BOOMITRA GRASSLAND RESTORATION IN EAST AFRICA THROUGH SOIL ENRICHMENT

Document Prepared by Earthood Services Limited

Report ID	VCS.VAL.23.102
Project title	Boomitra Grassland Restoration in East Africa Through Soil Enrichment
Project ID	3340
Crediting period	10-01-2019 to 09-01-2039
Original date of issue	30/11/2023

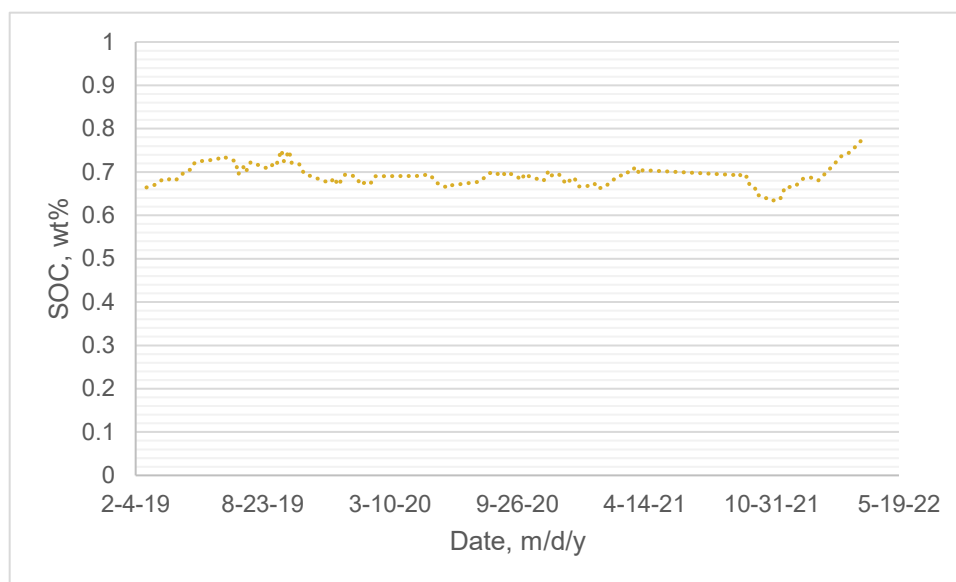
The column F deals with soc_increase(wt %). PP is requested to provide the clarification on conversion formula from wt% to carbon_stock_increase_yearly per acre (ton CO2/acre). PP is requested to substantiate the claim with research papers or the model values data that the effect of weather, including droughts, manifests itself indirectly through the change in carbon levels on the ground, which results in a different satellite measurement and resultant remote sensed SOC level. When there is a drought, carbon inputs in the soil decrease, leading to either stagnation or decrease in the soil carbon level.

soc_increase is actually converted to total_carbon_stock_increase_per_acre. 'carbon_stock_increase_yearly per acre' is not a required calculation parameter in this project, and may be removed from the spreadsheet. The conversion from soc_increase (wt%) to total_carbon_stock_increase_per_acre (tons CO2e/acre) happens by multiplying soc_increase by:

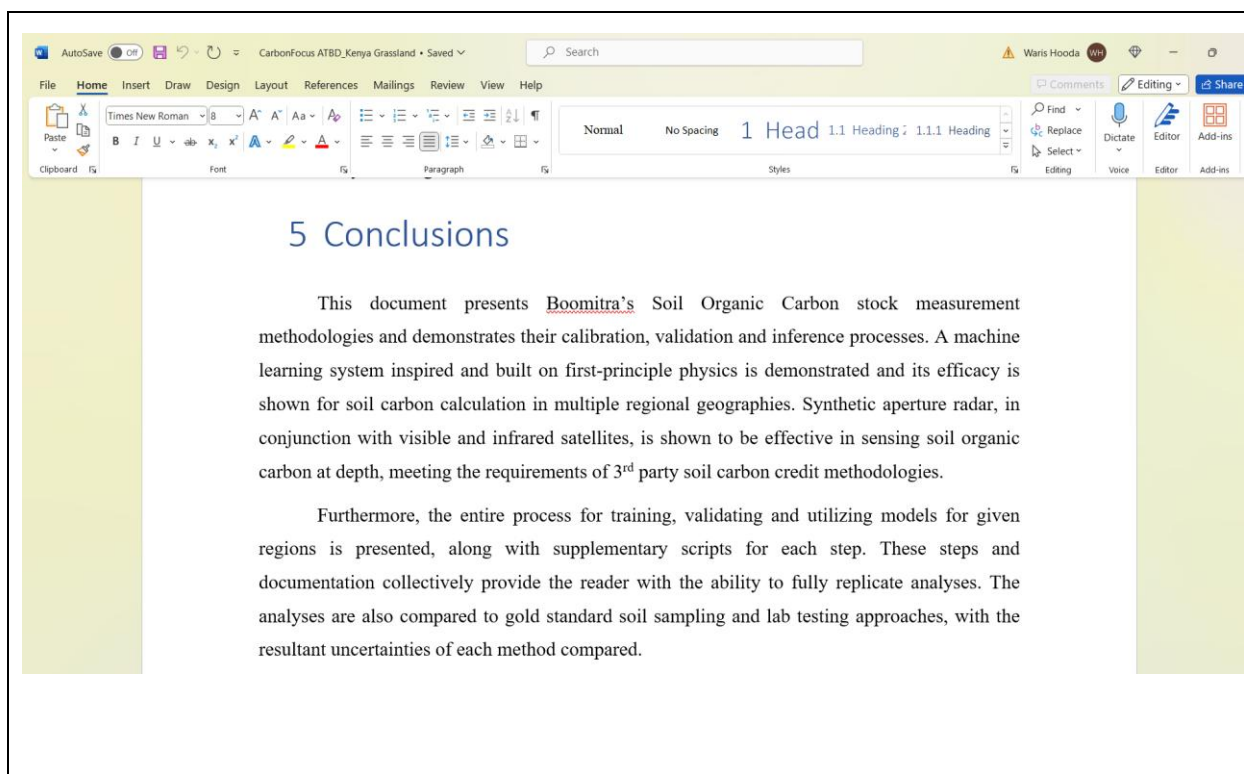
CL ID	16	Section no.	Date : 06/10/2023
Description of CL			
In Section 3.1.3 of "Carbon Focus Version 1.1," it appears that there is a gap in the document where it does not mention the specific soil carbon ranges, or the data cleaning procedure related to soil carbon data. This is a significant omission, as understanding the range of soil carbon values and the steps taken to clean and preprocess the data are crucial for transparency and reproducibility in scientific research. PP is requested to provide more details for assessment purpose.			
Project participant response			Date : 26/10/2023
Please refer to Section 5.1 of the ATBD, which details not only the cleaning procedures but also any numbers of points removed due to the cleaning.			
Documentation provided by project participant			
ATBD document v1.3			
DOE assessment			Date: 17/11/2023
In the current version, v1.2, of the ATBD document, Section 5 serves as the conclusion. PP is requested to provide details for assessment.

Project participant response	Date : 20/11/2023
Assessment has been provided in the latest ATBD document.	
Documentation provided by project participant	
DOE assessment	Date : 22/11/2023
PP has provided the details of soil carbon ranges and data cleaning procedure. This finding is closed now.

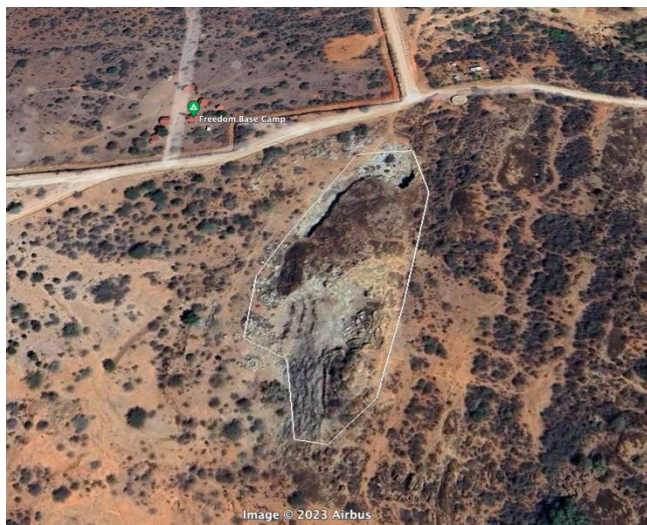
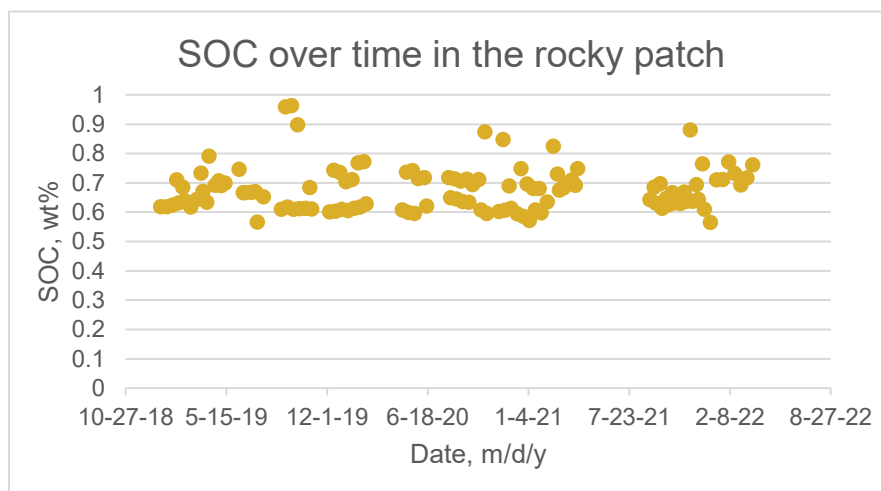
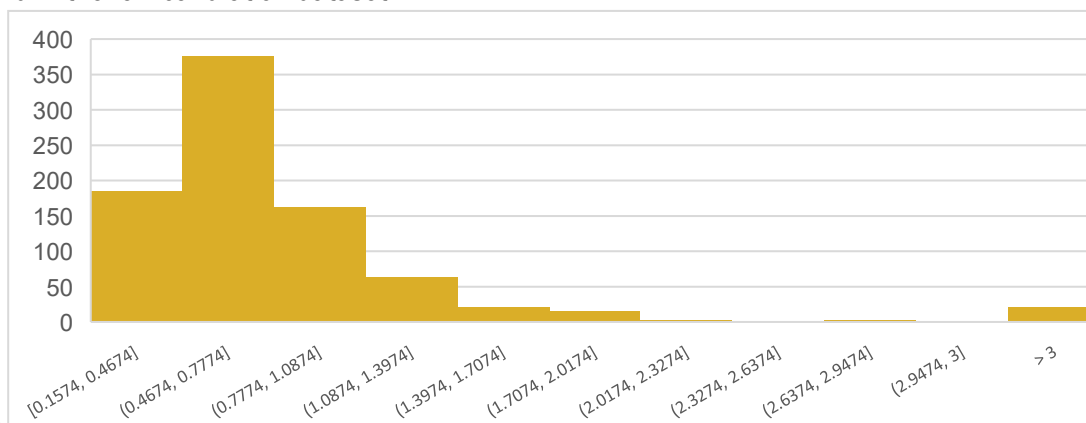
CL ID	27	Section no.		Date : 17/11/2023
Description of CL				
The audit team also noticed a few rocky patches (annexure-II) with PA. Soil particles are rarely seen on such rocky patches. Therefore, PP is requested to explain, how SOC is estimated on these rocky beds up to 30 cm depth.				
Project participant response				Date : 20/11/2023
Rocky areas were mostly identified in Kasanga ranch. We identified one such rocky area that spanned multiple acres (4.47 acres, the largest contiguous rocky patch that could be found, with all

1. Requesting clarification from PP regarding the observed SOC value of 0.7 wt% in the rocky patch figure. Considering the project's established SOC range for grassland (0-2 wt% for min & max), this value appears notably high for rocky features. Clarification is sought specifically on the SOC values, as this discrepancy might potentially lead to overestimations of ER in other soil areas, especially considering the high RMSE value of 0.25 wt% & some prediction values over the rock feature. Please note that the clarification is for the SOC values itself and not the change in carbon that is -0.001 wt%
18)
2. Furthermore a few spikes over the during the monitoring period raise concern over the data cleaning procedures. PP is requested to provide clarification on this aspect.

others <1 acre) to get an accurate calculation of soil carbon change as measured by our remote sensing that occurs over the course of a few years.

The location of the site is 1°27'10.89" S, 37°03'11.10" E.

When the SOC was studied with remote sensing over time, the following data was produced.

As seen in the above, the soil data does not show a discernable increase or decrease for this area. Furthermore, the same carbon credit quantification script used for the project scenario has been used on this data, and it is found that the measured carbon change is -0.001wt% per year (likely within the noise regime for a measurement of no change in soil carbon), which is very small relative to the 0.0342wt% increase observed on the overall Kasanga ranch yearly. Given that Kasanga is across 3739.91 acres and this largest rocky patch in Kasanga is 4.47 acres, the final effect of the rocky patch on the SOC wt% increase calculated for Kasanga ranch is $-0.001\text{wt}\% \times 4.47 \text{ acres} / 3739.91 \text{ acres} = -0.00000119 \text{ wt}\%$, which will not be perceptible in the final ER calculations, and is far below both the

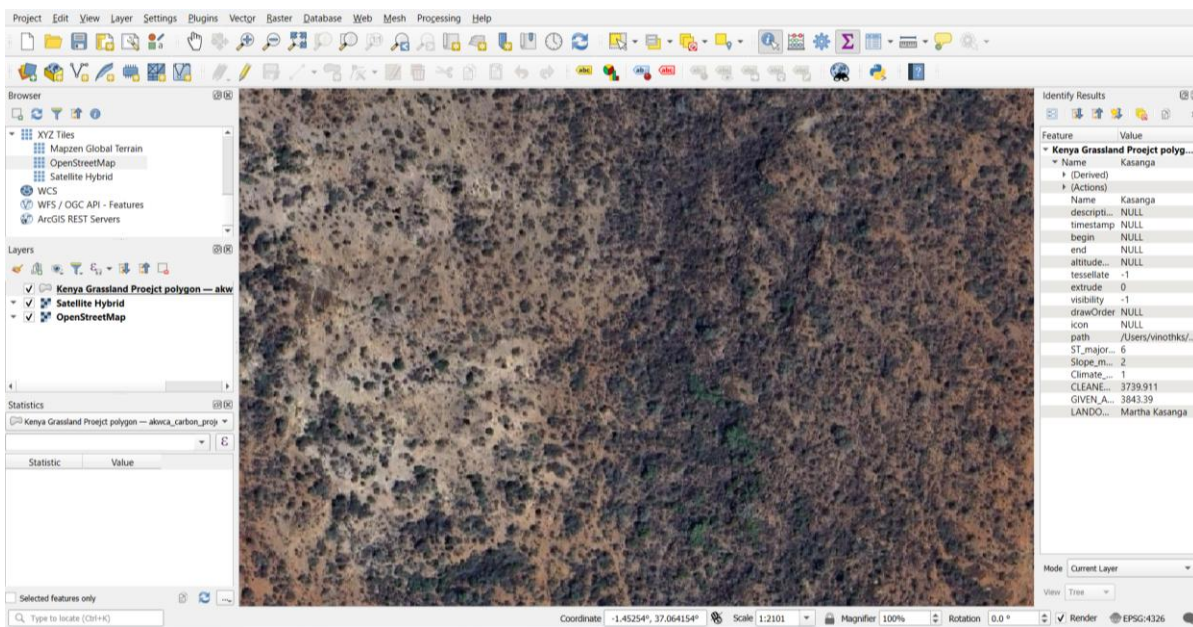
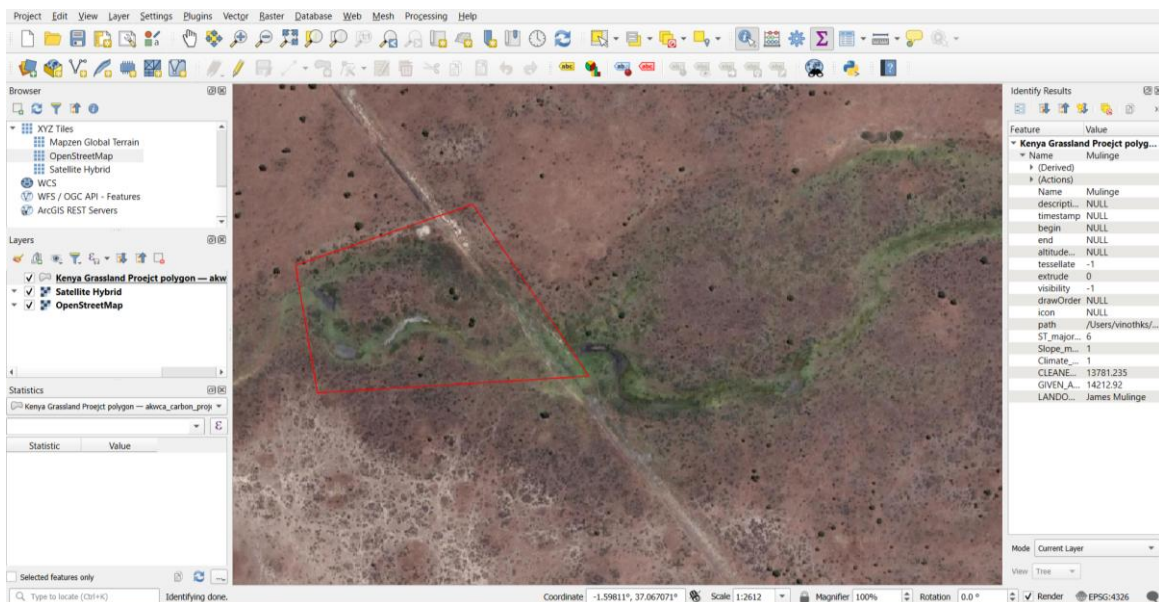
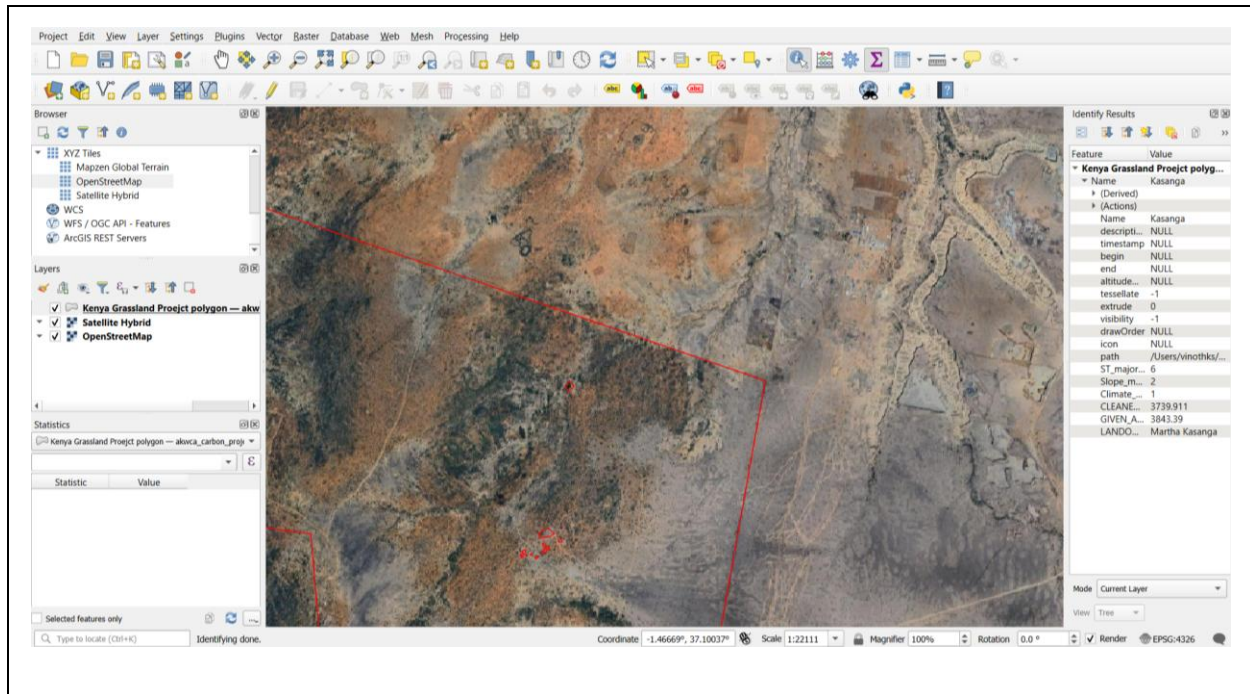
The revised KML is assessed. Notably the following issues require correction in KML. 1. Water body delineation in Mulinge. 2. Trees patches with canopy in Kasanga.

3. Rocky patches.

PP is requested to provide clarification regarding the accuracy of the project activity area demarcation, especially in cases where no natural or man-made features align precisely with the boundary demarcation. An explanation detailing the methodology or criteria used for delineating the project area boundaries despite the absence of clear natural or man-made features would be valuable for better understanding the accuracy and reliability of the demarcated area.

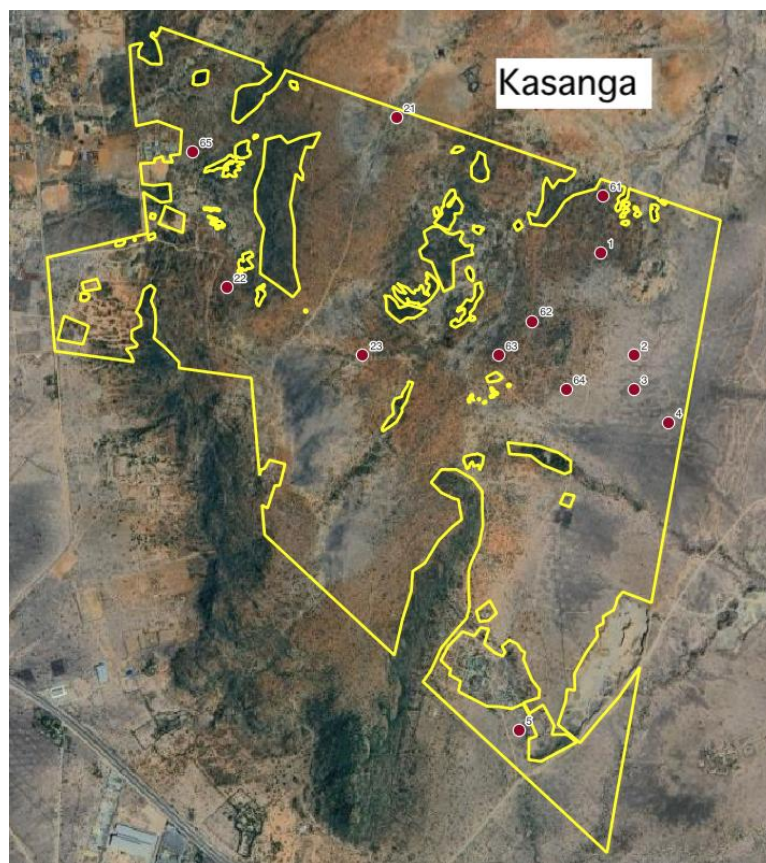
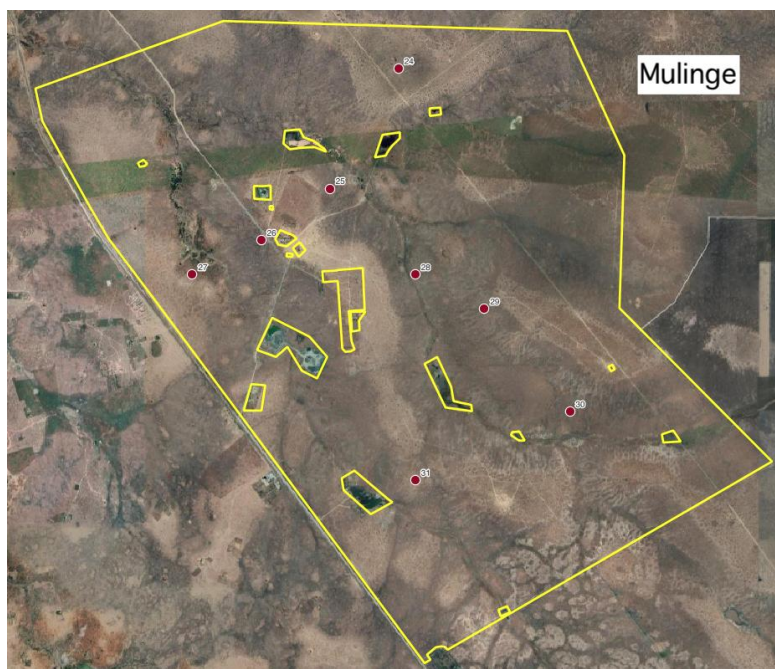
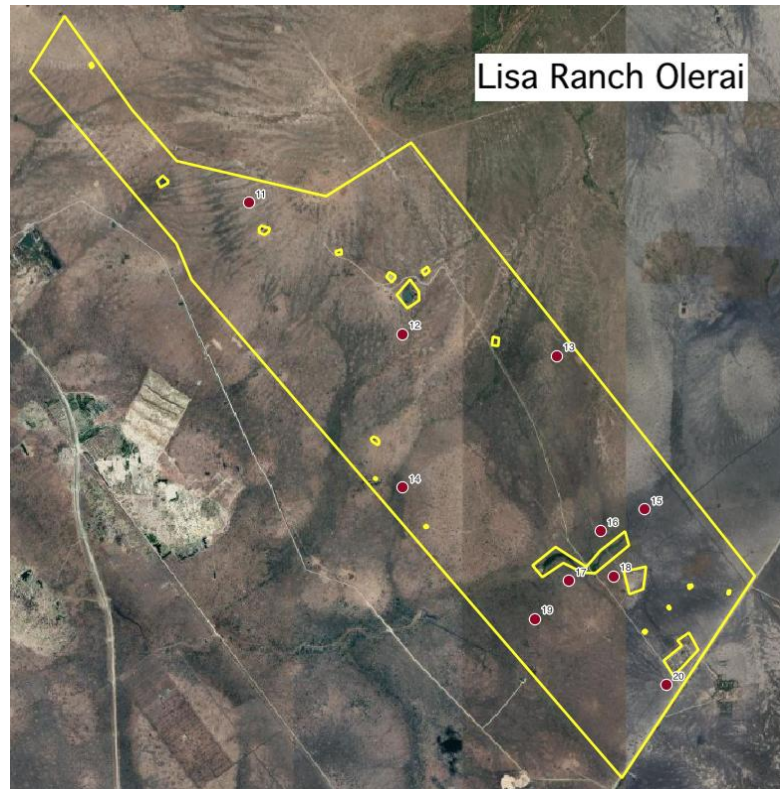
1. Ground samples are not collected by PP during validation; instead, PP intends to conduct ground sampling independently during verification for the months of January and February. In addition to this PP will be required to explicitly provide a data collection plan and number of samples collected within the project activity area in the technical document.

Response: For the verification soil samples the following procedures are implemented. In the case of the SOCwt%, soil samples are taken from demarked geocoded locations at a depth of 30cm with augers and then transported within 2-3 days to the collection facility of the testing lab used, for a dry combustion analysis of SOCwt%. In the case of BD, measurements are made near the field by the ground team, using the soil samples immediately after sampling.

Soil sampling locations are selected using a stratification based on the soil textures found within the project areas. The reason for this type of stratum is that the purpose of the soil sampling is primarily for the QA/QC of the remote sensing technology. Based on the scientific framework presented in Section 3 of the remote sensing report provided to the VVB and Verra, some of the main parameters affecting the physical process are the parameters having to do with the soil texture. Hence, we must ensure during soil sampling that all the soil textures in the project are individually sampled to the necessary level.

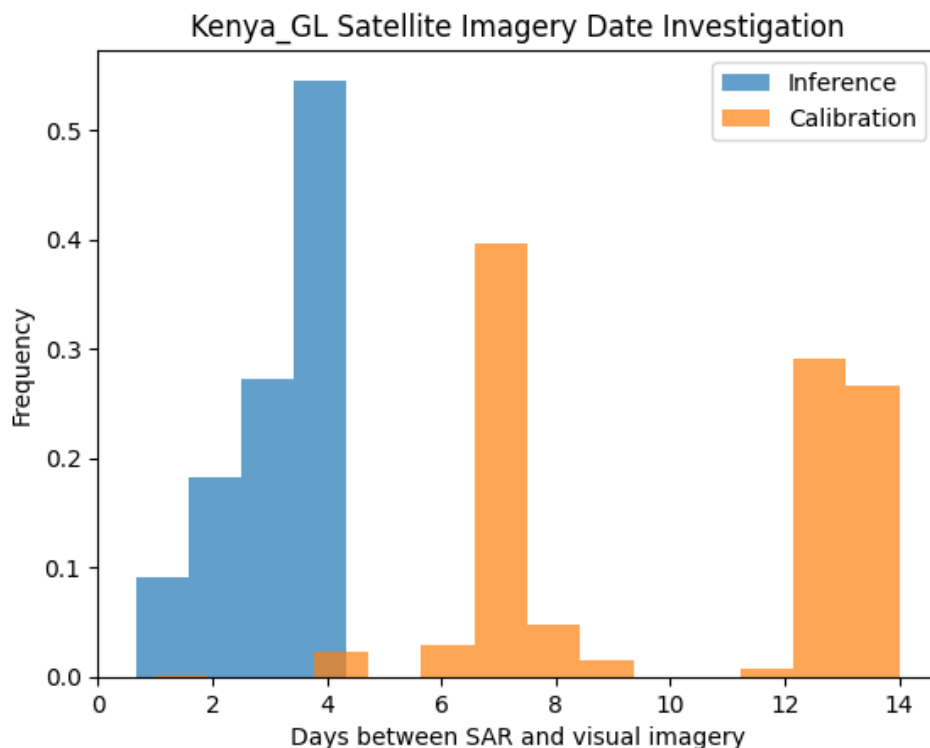
2. A detailed plan and information regarding the bias correction of Emission Reductions (ERR) are needed. This correction should account for the difference between RothC estimations resulting from project activity intervention and those obtained from remote sensing data or vice versa for baseline scenario.

Response: Our approach to bias correction in the improved practice project RothC model scenario involves a careful calibration process to ensure accurate estimates of Emission Reductions (ERR). Specifically, we fit the carbon input parameter of the RothC model to align with soil carbon measurements obtained via remote sensing, at the beginning and end of the project monitorin period. This method effectively accounts for discrepancies between RothC estimations and remote sensing data, ensuring that the model's output reflects the actual changes in soil carbon resulting from the project activities. By integrating these remote sensing measurements into our calibration, we address potential biases and enhance the reliability of our ERR estimates.

For the baseline scenario, bias correction can be accomplished by adjusting the RothC baseline change in carbon stock by the average bias measured from our literature validation set as documented in the Model Validation Report. However, our average bias on the literature dataset is 0.41 t/ha/year, indicating that our baseline RothC model bias is overestimating soil carbon stock gains. Subtracting this bias from our baseline scenario results on our project sites would in turn result in adding the bias to the calculation of emissions reduction, increasing the overall emissions reduction estimate of the project. Therefore, we believe it is more conservative in this case to refrain from adjusting the baseline scenario literature estimated bias in the ERR calculations. The Model Validation Report has been updated to reflect this finding.

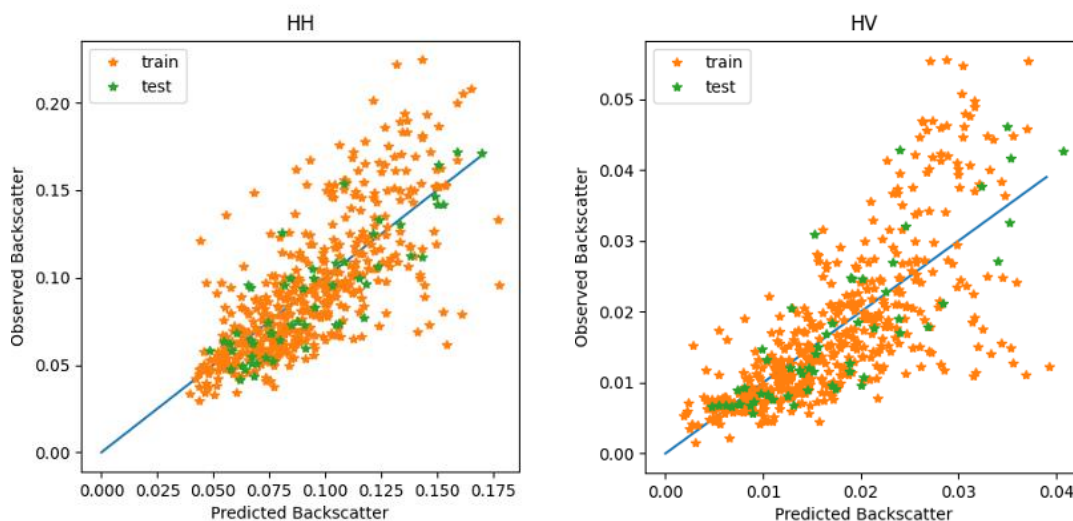
4. [What is our] Approach [to] soil data information for modelled soil moisture data or improved soil data information either ground based or other remote sensing data.

Response: For our soil carbon estimation model, we utilize the SMAP (Soil Moisture Active Passive) and SMOS (Soil Moisture and Ocean Salinity) soil moisture values. SMAP and SMOS provide high-resolution, global soil moisture data through advanced remote sensing techniques, combining both active and passive microwave measurements. Details of the methods and error associated with each satellite are described in Section 4.4.1 of the ATBD.
